Access Compliance Report

Public Rights-of-Way

(Curb Ramps)

Intersection ID: N/A	Main Street: TYVOLA_RD	Cross Street: I-77	Location: SE
ADA ID: 96856163B4E1	Ramp Type: BlendTrans1	Initial Pass/Fail: Pass	Overall Compliance: No
Severity Score: 10.25			
Codes/Mitigation Info/Possible Solution		Field Measurements/Component Compliance

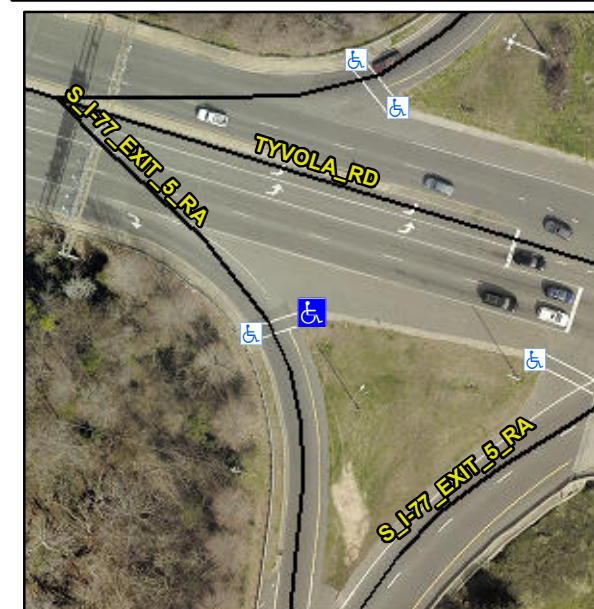
Remove & Replace Curb Ramp With Two New Directional Ramps or Equivalent. Remove & Replace Gutter.

R304.2.2-Perp, R304.3.2-Para, R305, R304.5.3
